MEMORANDUM

REVIEW TYPE: Preliminary Plan of Subdivision

PROJECT NAME: Academy Child Development Center

CASE #: 120090270

PROJECT DESCRIPTION (Fig. 2)

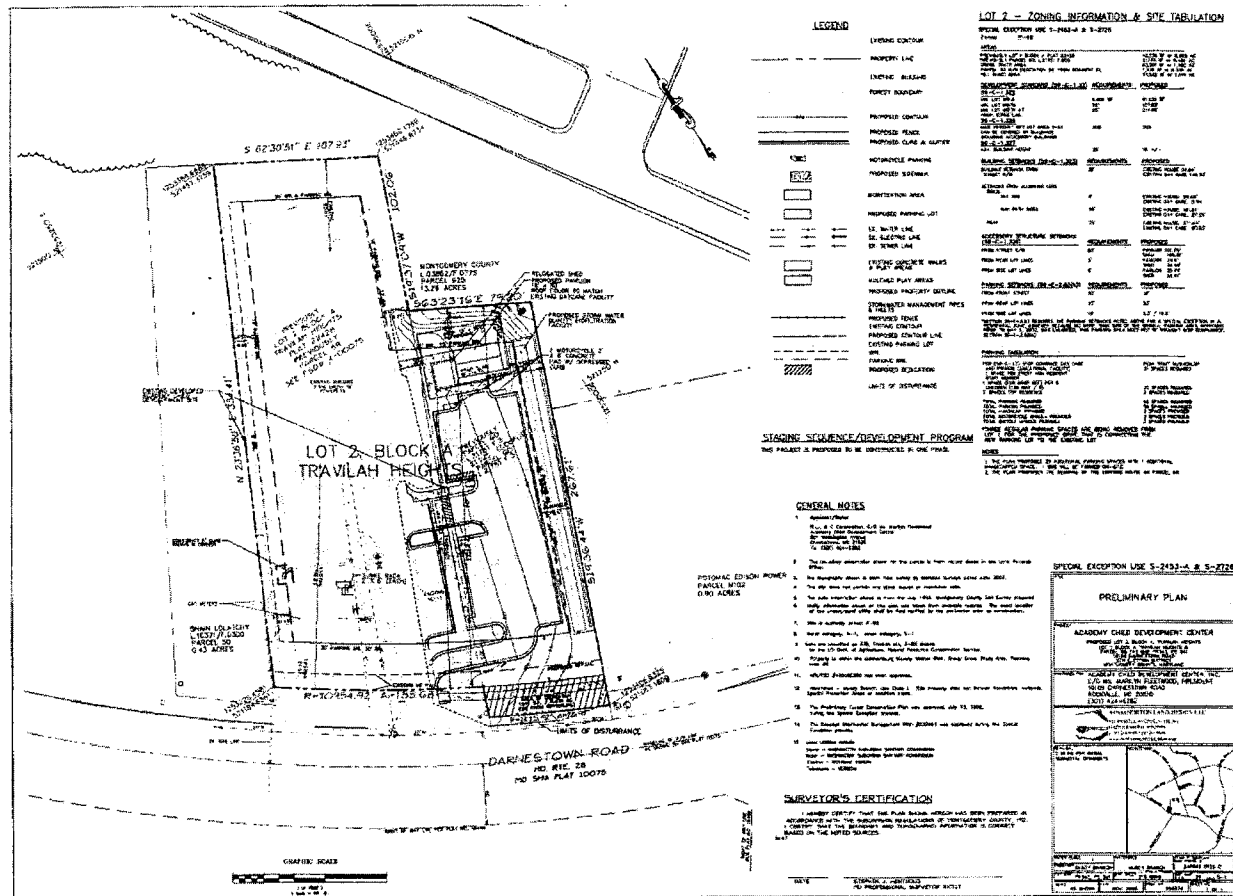
Two existing access points (driveways) are shown along the frontage of MD 28. The easternmost driveway is currently left/right-in and right-out only for all vehicles; limited because of site distance restrictions. The westernmost driveway is an exit only and limited to right-out only, again due to site distance restrictions. The applicant petitioned the Hearing Examiner, at the time of the special exceptions, to also support left-out turn movements for trucks and busses only and the request was apparently supported as stated under Condition #7 which reads:

The applicant has worked with MCDOT, and MCDOT has made the necessary findings to allow left/right-out only at the westernmost driveway, but only for trucks and busses. Passenger vehicles will be restricted from using the westernmost driveway. New site distance studies for this driveway showed that only trucks and busses can safely turn left out of this driveway because, by design, the driver sits at a higher elevation relative to the road surface thereby allowing farther sight lines. By condition of the MCDOT approval, the applicant will need to

Two existing site access points from Darnestown Road will remain unchanged. The applicant has requested to remove restrictions on the left turn movements out of the easternmost driveway to allow such movements by trucks and buses only. MCDOT has reviewed this request with the amended sight distance study submitted by the applicant and approved the left turn movements for trucks and buses only, not passenger vehicles. The Applicant will be required to execute a new Traffic Order with MCDOT that legalizes this movement. MCDOT has required that the Traffic Order be executed prior to issuance of access permits. Staff accepts MCDOT's findings regarding the requested traffic operational change.

- 7) The applicant must comply with the conditions of the Montgomery County Department of Transportation (MCDOT) approval dated June 26, 2009, including the requirements for the revision to the turning restrictions at the easternmost access point. These conditions may be amended by MCDOT provided the changes do not conflict with any other condition of the preliminary plan approval.
